# Service Information Bulletin

B52 09 20

## HEAD RESTRAINT AND/OR BACKREST OF 3<sup>RD</sup> ROW SEATS CANNOT BE FOLDED DOWN

This Service Information Bulletin (Revision 10) replaces SI B52 09 20 **dated December 2024**.

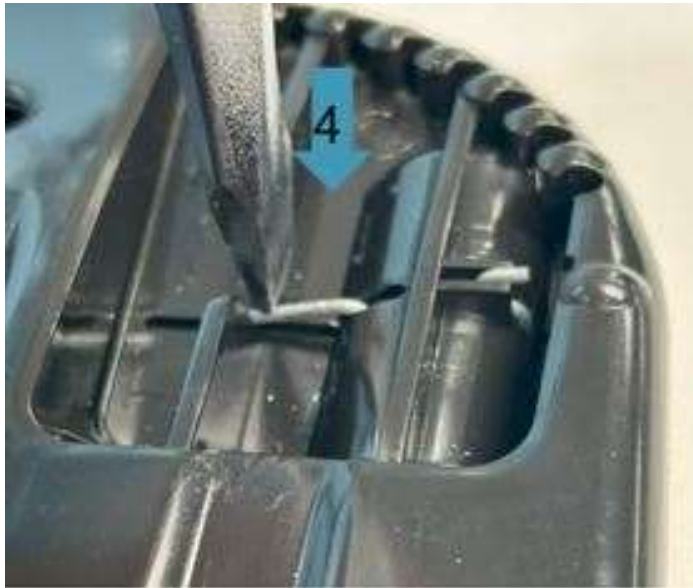
**NOTE:** The Electric Actuator for third-row seat changed design and part number as of March 28, 2025. The improved part fits all production date vehicles. The new actuators' spindle drive turns in the opposite direction from the previous design requiring a change in vehicle software.

- When installing this improved actuator into a vehicle **built prior to March 28, 2025 you must replace the headrest actuators in both the drivers and passengers third-row seats at the same time AND perform ISTA/P conversion "Replace 3rd row actuator"**. This will add +AA3S into the Vehicle Order to reverse the spindle drive direction.
- There is a note about this retrofit added into Test Plans

**52 20 9 473 697** Actuator folding backrest for vehicles built prior to March 28, 2025 (**part to be discontinued**)

**52 20 5 B6C 6A1** Actuator folding backrest for vehicles built after March 28, 2025.

- When installing this improved actuator into a vehicle **built after March 28, 2025 only replace the defective side**.
- See SI **B52 10 25** regarding the new design actuator.

**Cable routing UP TO February 2023 shown.**

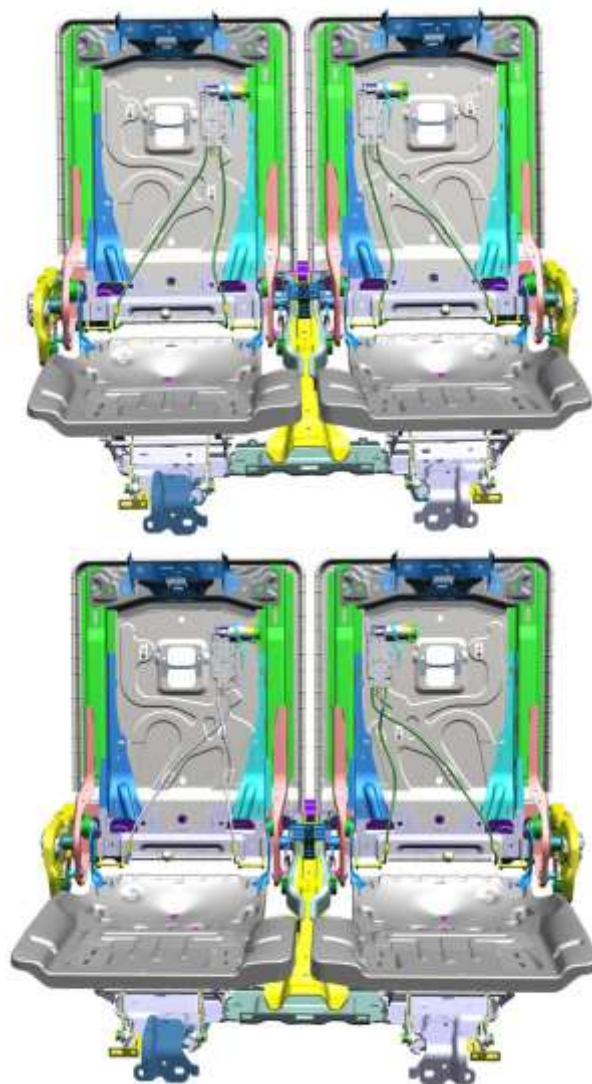
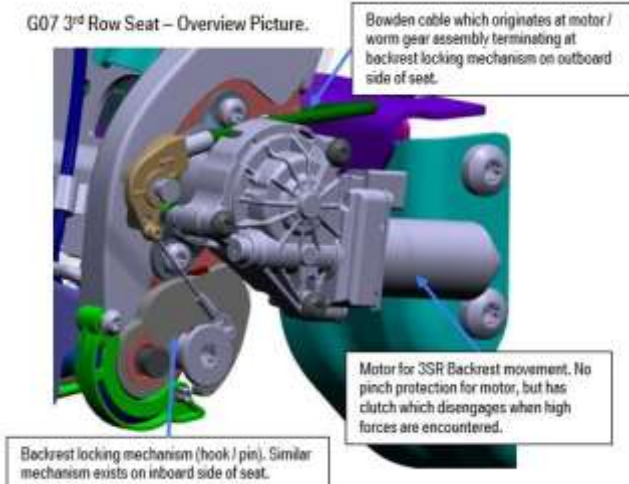
**NOTE:** A Bowden cable routing change was made in the third seat row backrest. This change was implemented starting in February 2023 production.

Replacement parts are all the new shortened design cable and require a new routing to install in vehicles produced prior to February 2023.

See Service Bulletin **B52 14 23**
